# ENGAGEMENT REPORT

Draft Design Standard for Residential Driveway  
Crossovers and Associated Code Amendment

By the State Planning Commission

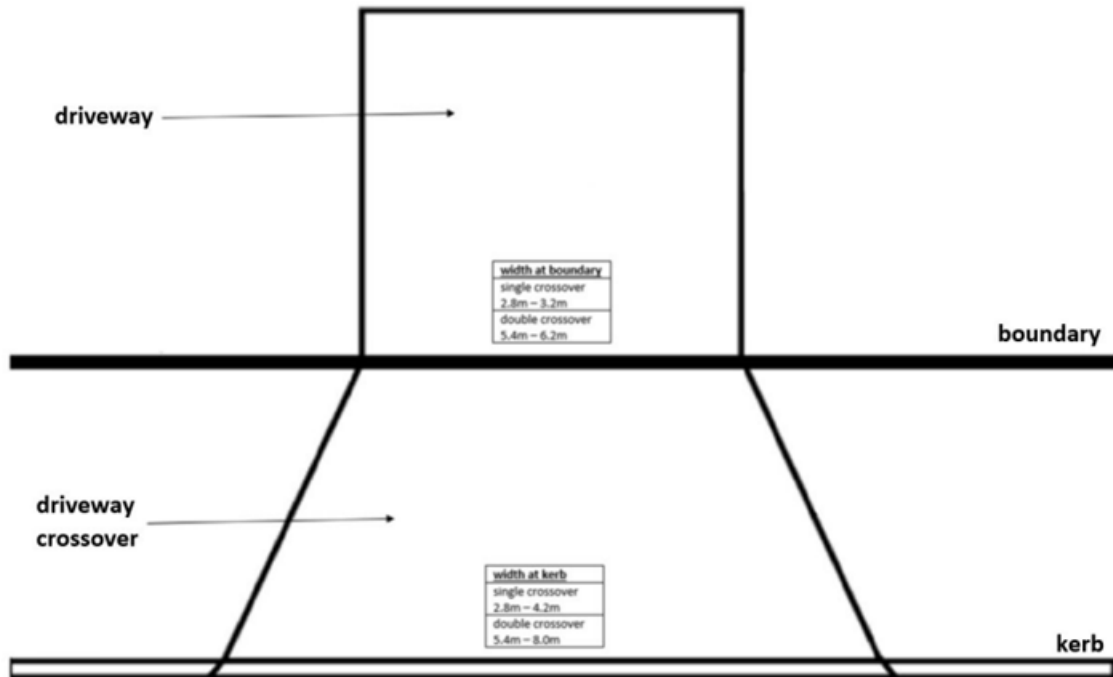
- **Which guidelines should be referenced for the sight distance assessment**  
– I note that the sight distance requirements in the '*Design Standard for Residential Driveway Crossover*' 5.2 (c) are derived from Table 3.2 of the Austroads *Guide to Road Design Part 4A* guidelines under the NDD conditions. However, the sight distance requirements in 5.2 (d) are derived from Figure 3.2 of AS/NZS 2890.1:2004 under the column of 'Minimum Stopping Sight Distance Requirement'. That is, two different guidelines have been adopted.

I note that the guidelines AS/NZS 2890.1:2004 is proposed to be revised in the near future and from my review of the initial draft revisions, it would appear that the Figure 3.2 (which Section 5.2 (d) proposes to adopt) would likely be significantly changed. Given the anticipated revision of AS/NZS 2890.1:2004, this reference may not be relevant for much longer. At least in the **Urban Transport Routes Overlay**, the sight distance requirements are referenced from a single guideline, i.e. the Austroads *Guide to Road Design Part 4A* and any future revisions would be more easily tracked.

In summary, there are concerns with the inconsistency aspects of the sight distance assessment, having regard to **PO 5.1, DTS/DPF 5.1** in the **Urban Transport Routes Overlay** and the sight distance requirements proposed in the '*Design Standard for Residential Driveway Crossover*' 5.2 (c) and 5.2 (d). There is also concern with the potentially wide differences arising from setting different sight distance requirements between State Maintained Roads and Council roads. The adoption of sight distances from AS/NZS 2890.1:2004 for 5.2 (d) is also of concern, given the likely changes to these guidelines in the near future and also the approach of referencing two different guidelines for the same sight distance assessment.

It is recommended that a consistent approach be considered and that a wider assessment of the Planning and Design Code be undertaken for the critical sight distance aspects rather than focussed solely on *Part 4 – General Development Policies*.

TD-B Urban driveway crossover widths- servicing three (3) or more dwellings

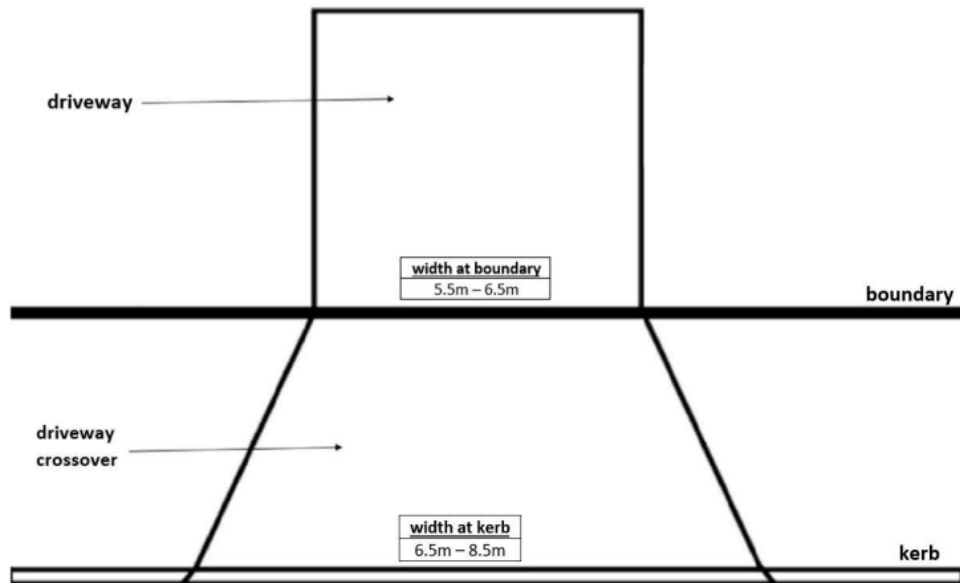
- TD-B appears to have a sliding scale for the width at boundary and width at kerb which is not understood why. Key to this diagram is linking it to the road width to enable identification of appropriate width at kerb and boundary.
- The absolutely critical inclusion must be consideration of the width of road (which can include road verge on the subject property side) which is available adjacent to the driveway to enable appropriate turning manoeuvrability to enter and exit a driveway.

### TD-C Urban Driveway Crossover Locations

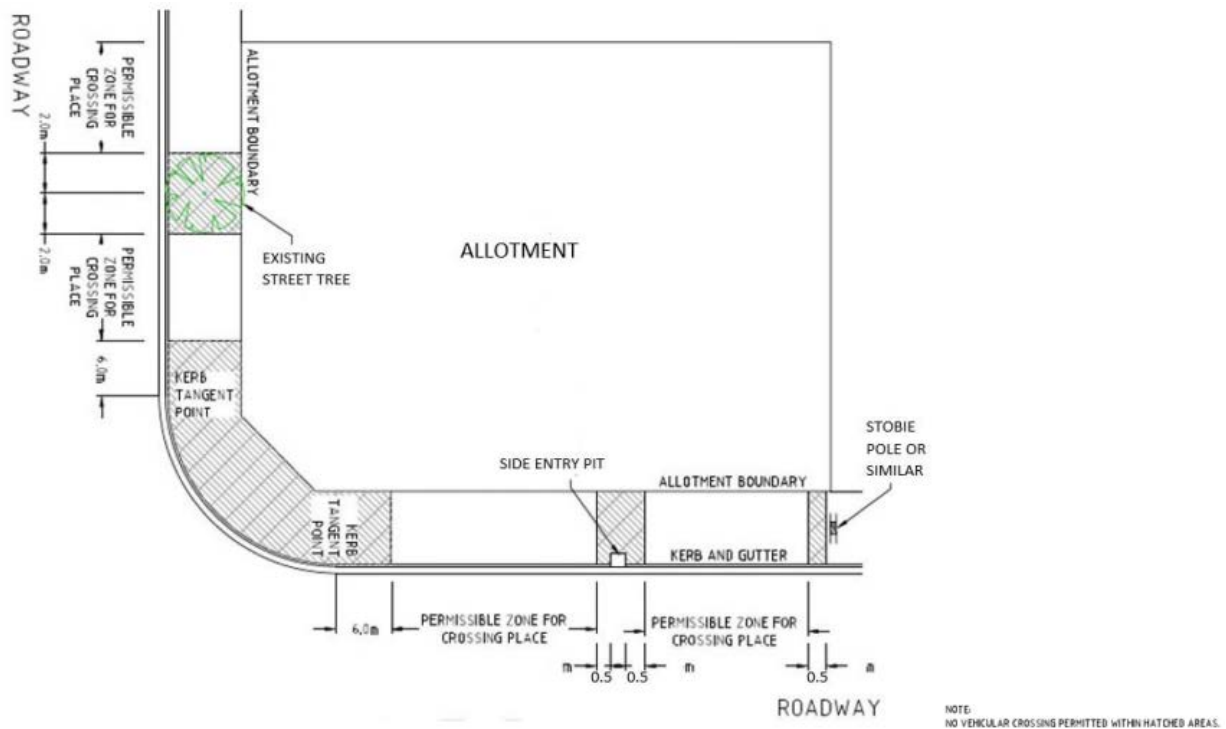
- On review of TD-C a number items are put forward for consideration and that also seek alignment with suggestions put forward for DR 1.6 Table:
  - 1.0m shown either side of the side entry pit
  - Ensure consistency between DR 1.6 Table

### TD-D Sightlines

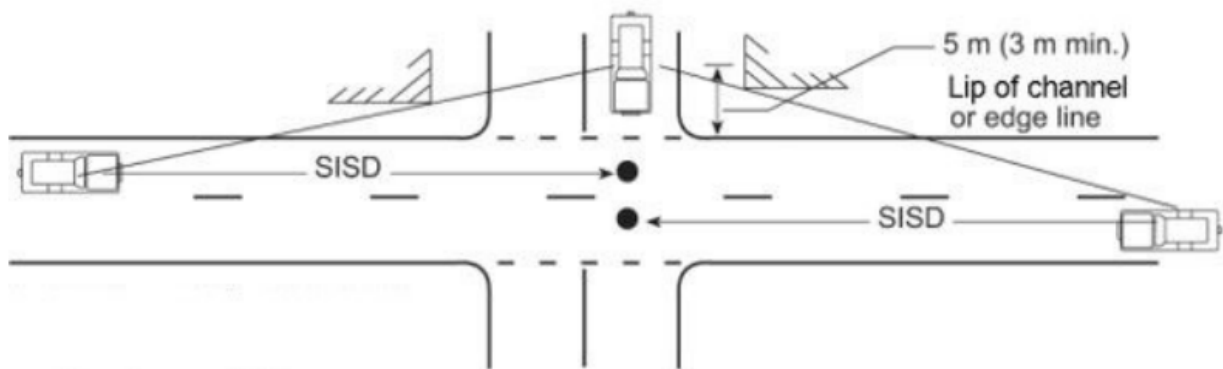
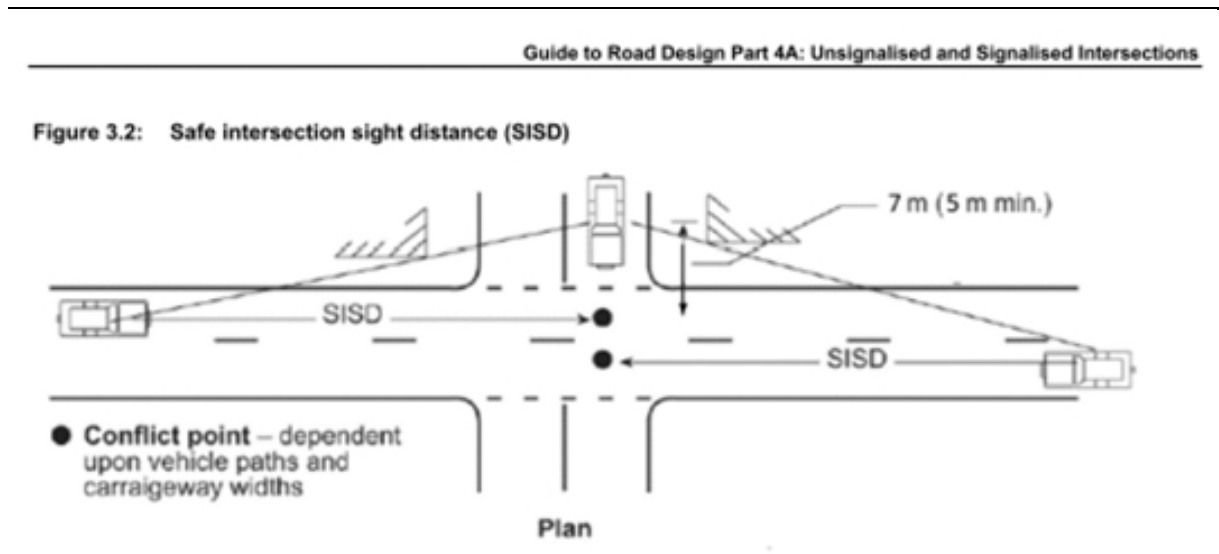
- The **TD-D diagram** above for the draft Design Standard was originally adopted from the Austroads *Guide to Road Design Part 4A* guidelines. This sight line figure has recently been updated in the Austroads *Guide to Road Design Part 4A 2023*, with a subtle change to the positioning of the exit vehicle for the assessment. Previously the setback distance was measured from the alignment of the kerb. The setback distance in the 2023 revised guidelines is now measured from the centre of the left-hand side lane (see below).

- The **TD-D diagram** should be updated to reflect the figure in the Austroads *Guide to Road Design Part 4A 2023* to achieve consistency. Updated diagram in Austroads guidelines below:

TD-F Driveway crossover grades- allotment lower than the road

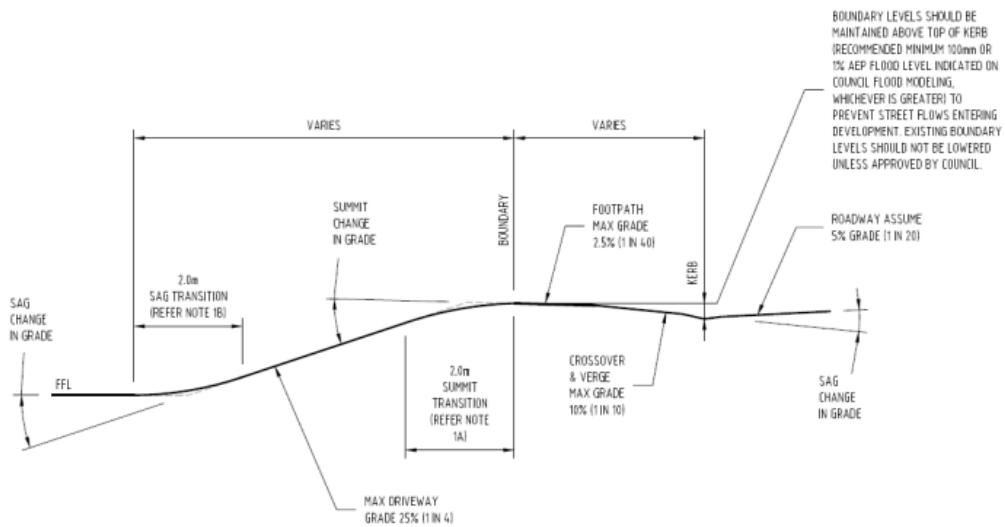
- Reference to TD3, when it has been put forward as TD-F Driveway crossover grades- allotment lower than the road.
- Incorrect assignment to note for 2.0m SAG transition.
- Incorrect assignment to note for 2.0m Summit transition.

**TD-H Footpath transitions and crossfalls**

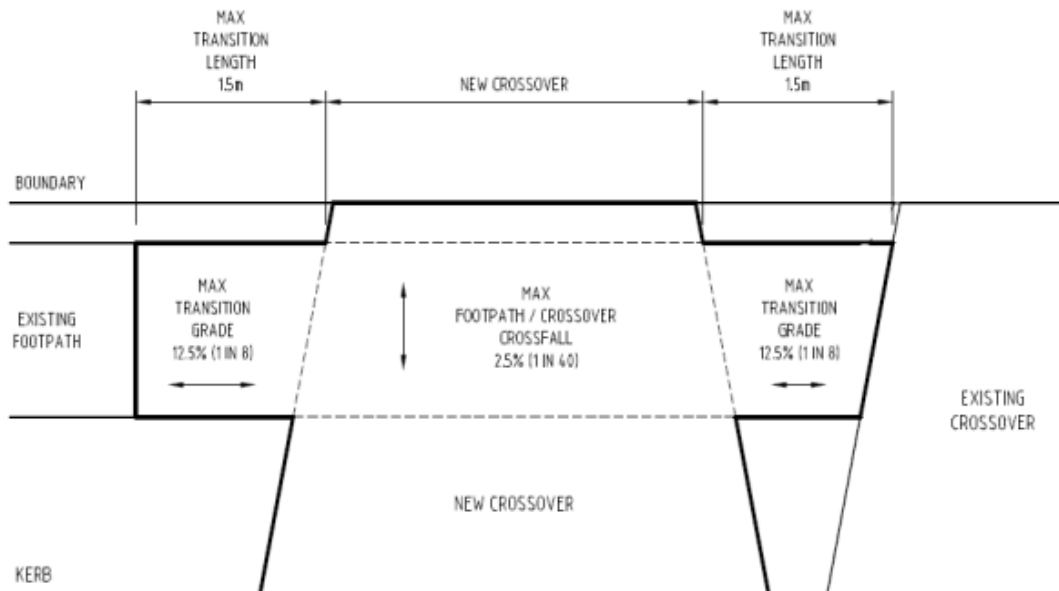
- Two-way arrow shown for max footpath/crossover crossfall. This should be a one way (down) arrow.
- Recommend that reference to AS 1428- Design for Access and Mobility is included.

- Pedestrian Sightlines

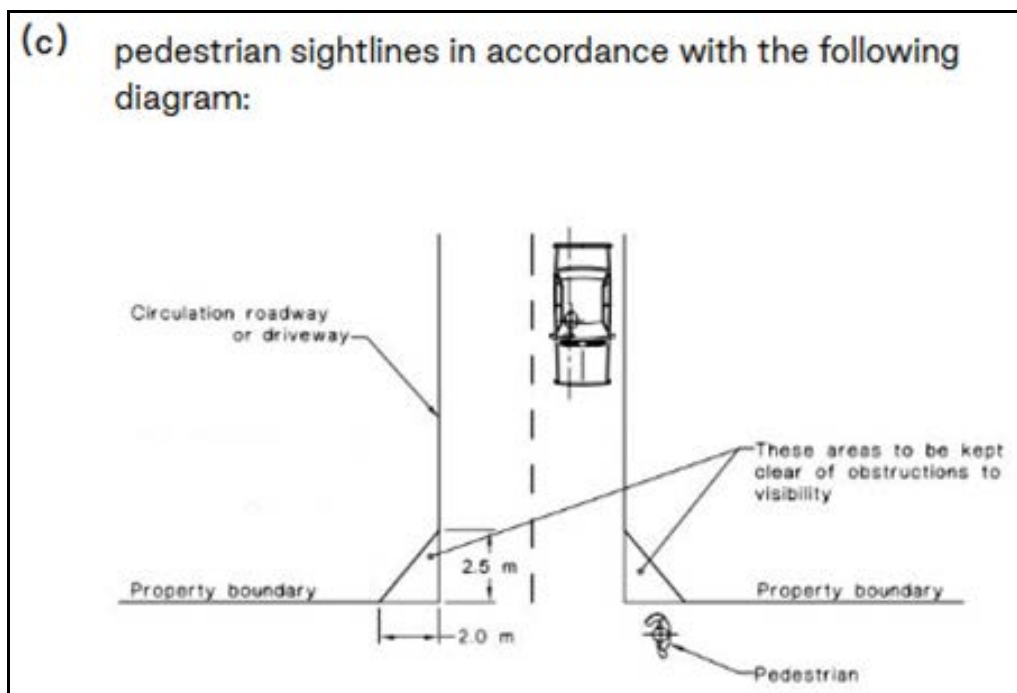
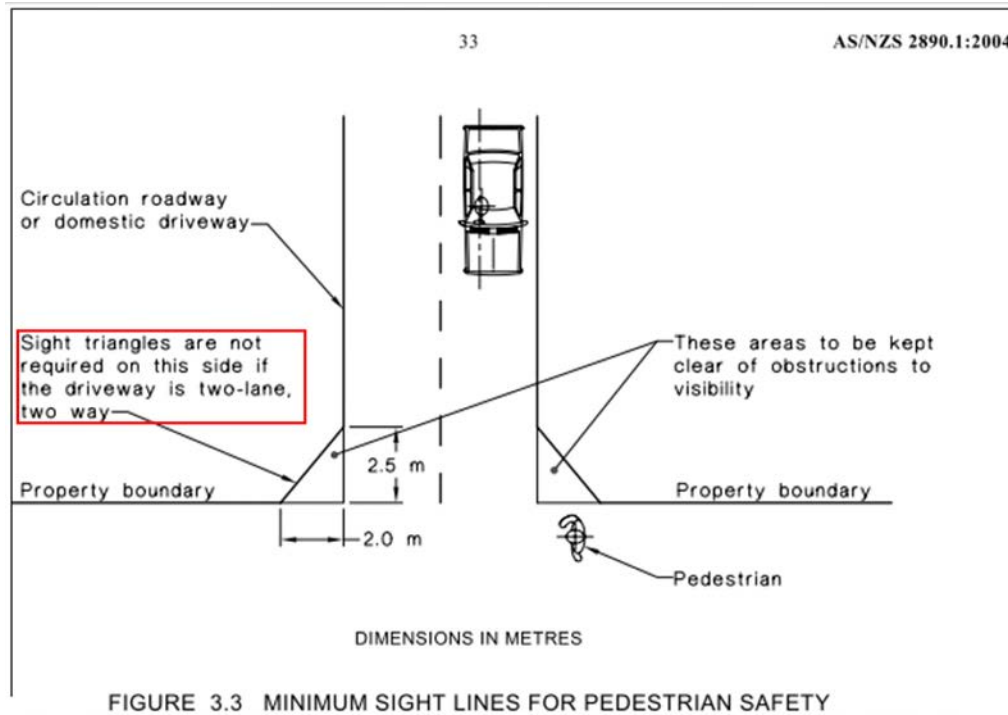
As a separate comment, the above figure in the Planning and Design Code for the pedestrian sight line is a derivation from Figure 3.3 of AS/NZS 2890.1:2004 (see below). I believe that the Planning and Design Code diagram is incorrect. The Figure from AS/NZS 2890.1:2004 states that if it is a two-way driveway, the pedestrian sight triangle on the right-hand side of the exit driver is not required, because the entry lane already provides the 'clearance distance' to view the approaching pedestrian, which is a logical observation.

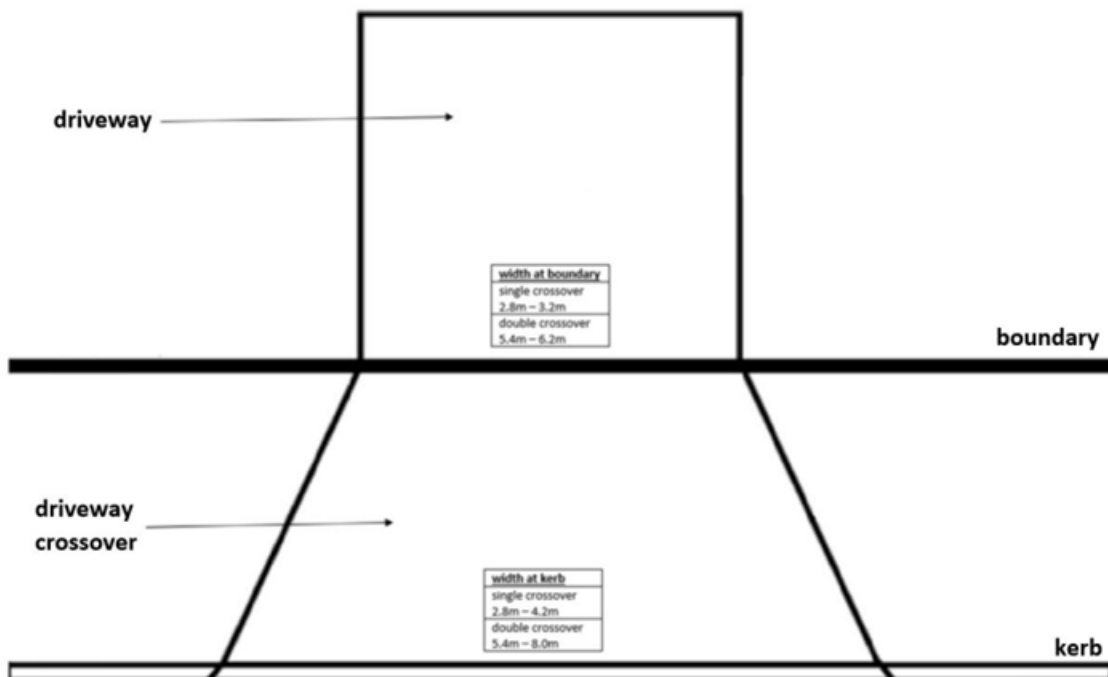
- **Which guidelines should be referenced for the sight distance assessment** – I note that the sight distance requirements in the '*Design Standard for Residential Driveway Crossover*' 5.2 (c) are derived from Table 3.2 of the Austroads *Guide to Road Design Part 4A* guidelines under the NDD conditions. However, the sight distance requirements in 5.2 (d) are derived from Figure 3.2 of AS/NZS 2890.1:2004 under the column of 'Minimum Stopping Sight Distance Requirement'. That is, two different guidelines have been adopted.

I note that the guidelines AS/NZS 2890.1:2004 is proposed to be revised in the near future and from my review of the initial draft revisions, it would appear that the Figure 3.2 (which Section 5.2 (d) proposes to adopt) would likely be significantly changed. Given the anticipated revision of AS/NZS 2890.1:2004, this reference may not be relevant for much longer. At least in the **Urban Transport Routes Overlay**, the sight distance requirements are referenced from a single guideline, i.e. the Austroads *Guide to Road Design Part 4A* and any future revisions would be more easily tracked.

In summary, there are concerns with the inconsistency aspects of the sight distance assessment, having regard to **PO 5.1, DTS/DPF 5.1** in the **Urban Transport Routes Overlay** and the sight distance requirements proposed in the 'Design Standard for Residential Driveway Crossover' 5.2 (c) and 5.2 (d). There is also concern with the potentially wide differences arising from setting different sight distance requirements between State Maintained Roads and Council roads. The adoption of sight distances from AS/NZS 2890.1:2004 for 5.2 (d) is also of concern, given the likely changes to these guidelines in the near future and also the approach of referencing two different guidelines for the same sight distance assessment.

It is recommended that a consistent approach be considered and that a wider assessment of the Planning and Design Code be undertaken for the critical sight distance aspects rather than focussed solely on *Part 4 – General Development Policies*.

### TD-B Urban driveway crossover widths- servicing three (3) or more dwellings

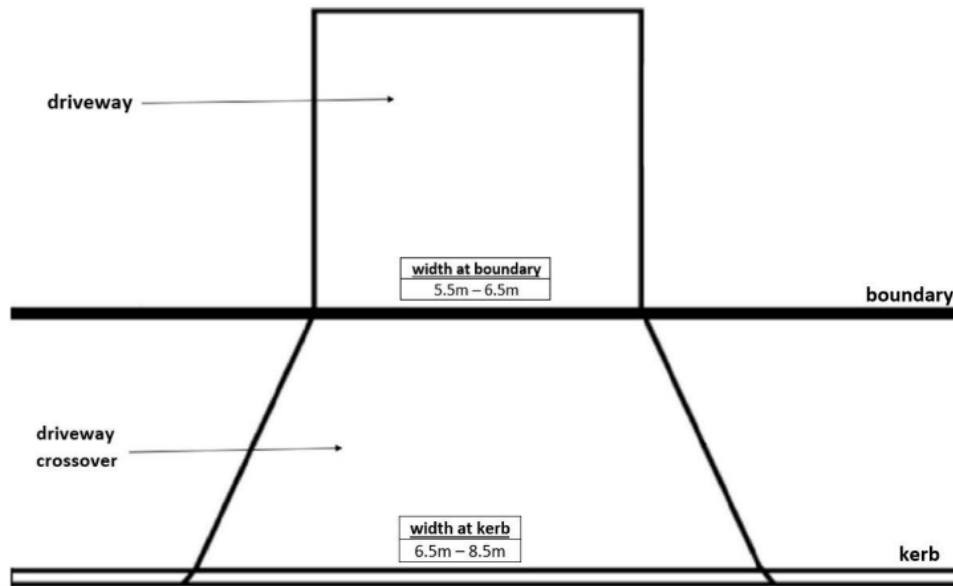
- TD-B appears to have a sliding scale for the width at boundary and width at kerb which is not understood why. Key to this diagram is linking it to the road width to enable identification of appropriate width at kerb and boundary.
- The absolutely critical inclusion must be consideration of the width of road (which can include road verge on the subject property side) which is available adjacent to the driveway to enable appropriate turning manoeuvrability to enter and exit a driveway.

**TD-C Urban Driveway Crossover Locations**

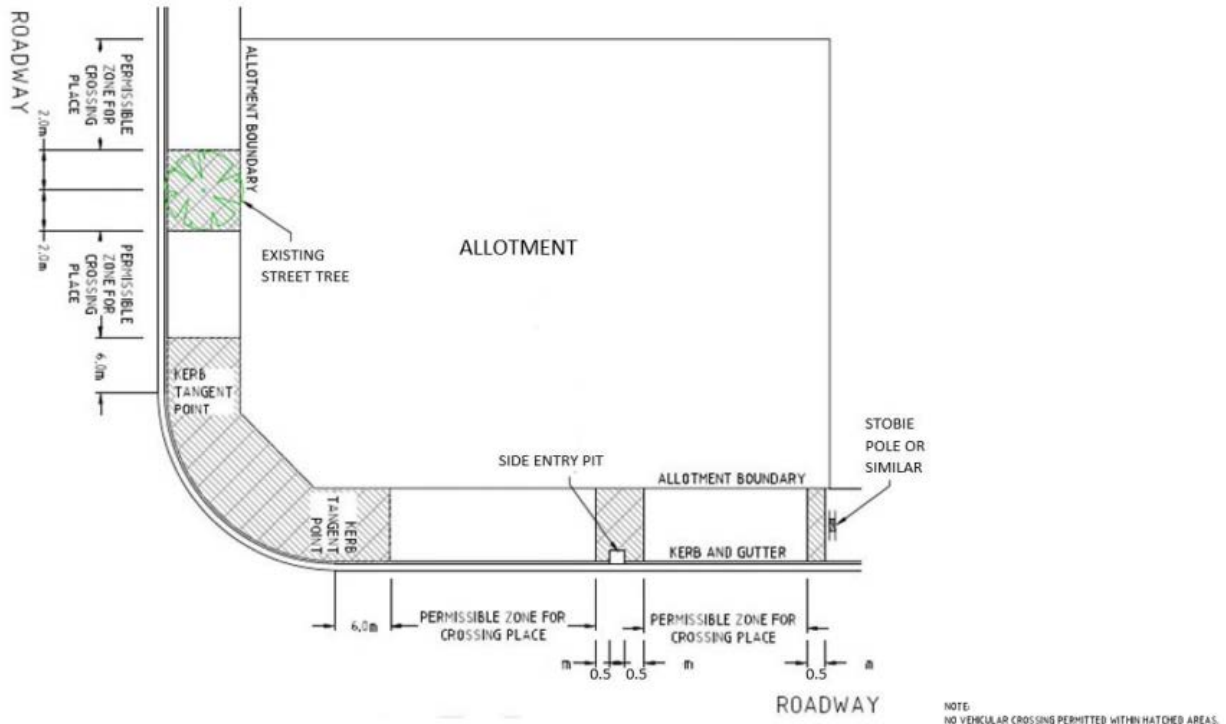
- On review of TD-C a number items are put forward for consideration and that also seek alignment with suggestions put forward for DR 1.6 Table:
  - 1.0m shown either side of the side entry pit
  - Ensure consistency between DR 1.6 Table
